# Access Compliance Report

## Public Rights-of-Way

### (Pedestrian Signals)

Intersection ID: N/A	Main Street:	Cross Street: N/A	Location: N/A
ADA ID: D188545E1CAD	Signal Type: One Push Button-Non APS	Overall Compliance: No	Severity Score: BTN 1: N/A BTN 2: N/A No BTN: N/A
Codes/Mitigation Info/Possible Solution		Field Measurements/Component Compliance

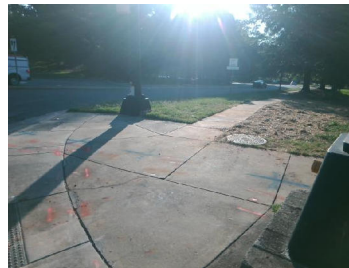
Surveyor Notes: TEXT HT 1/2

PROW/ADA: R410.6, TMUTCD 4e.08, R404.2, R406.2

Possible Solutions: Replace Signal Push Button With APS Button on New Post. Remove & Replace Sign.
